Proposed Stormwater Management Regulatory Requirements for New Development and Redevelopment in Maryland

D. Lee Currey, Director, Water and Science Administration
Maryland Department of the Environment

August 25, 2023

Thank you for the opportunity to comment on the revised A-StoRM proposal forwarded July 26, 2023. In general, we think that it is much improved and makes a serious effort to address climate change while working within practical technical and regulatory constraints.

Subsection a, Page 4: Use of NOAA Precipitation Statistics

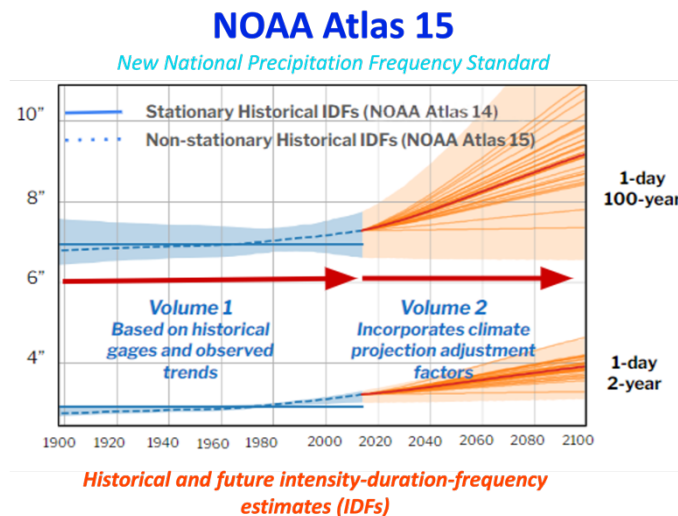
While it is important that no local government in Maryland reference TP40, and while it is imperative that, at a minimum, the Maryland Design Manual require that all local regulations must reference NOAA Atlas 14 (NA14) (2006 update), it is true that some counties are already referencing NA14 and yet are still experiencing flooding. NA14 methods as discussed in our previous comments are based on historical values that no longer reflect current trends toward more intense, short duration rainfalls (e.g., 3-hour, 6-hour, 12-hour, 24-hour, etc.) across the temporal spectrum (e.g., annual, 2-year, 25-year, 100-year rainfall, etc.). We understand that, taken together with other proposed changes resilience may be improved using these values. However, our main critique of the current proposal is as follows:

- We are particularly disturbed that there is no reference to adopting future changes in the NOAA precipitation frequency data server (PFDS). Specifically, Congress has mandated NOAA to revise

these statistics *at least* every ten years. In fact, we know that NA15³ will be coming out in in 2026 in two volumes:

Volume 1 will account for temporal trends in historical observations, and **Volume 2** will use future climate model projections to generate adjustment factors for Volume 1. To account for a changing climate, NOAA worked with the Federal Highway Administration (FHWA) and the academic community to develop a new methodology for Atlas 15, which has undergone broad review by stakeholders and Federal partners over the past year, leveraging state of the art research in extreme value theory and climate model outputs and projections. The Atlas 15 estimates will provide critical information to support the design of state and local infrastructure nationwide under a changing climate.

It is essential that MDE incorporate an automatic adoption of the most current NOAA atlas and in this case a prospective requirement to adopt NA15. This is especially important given the long lag times from federal standards to state statutory authorization, to state agency regulatory development, to county amendments of local ordinances, to industry adoption of new practices, to implementation. Failing to include this automatic requirement builds in unnecessary lag times in an already long, drawn out process.

- Less critical but still worth considering is the assumption that Maryland will continue to base requirements on the average annual 24-hour storm. NOAA provides max, min, and average values; rain is falling in more intense short duration storms; and some jurisdictions nationwide reference the 2-year storm for their stormwater system design rather than the 1-year. We would like to see a discussion of why, as stated as a matter of fact rather than as a matter for consideration: “Maryland uses average rainfall depths associated with a 24-hour duration storm event as the basis for stormwater management requirements and best management practice design.” Given the progressively increasing intensity of rainfall, we believe that MDE should consider referencing NOAA’s max rainfall depth and/or the 2-day duration storm.

- We request that MDE institute and fund a robust plan to gather local rainfall records for the 12-hour, 6-hour, and 3-hour durations to inform future regulatory and best practice advice on improving resilience throughout the state.
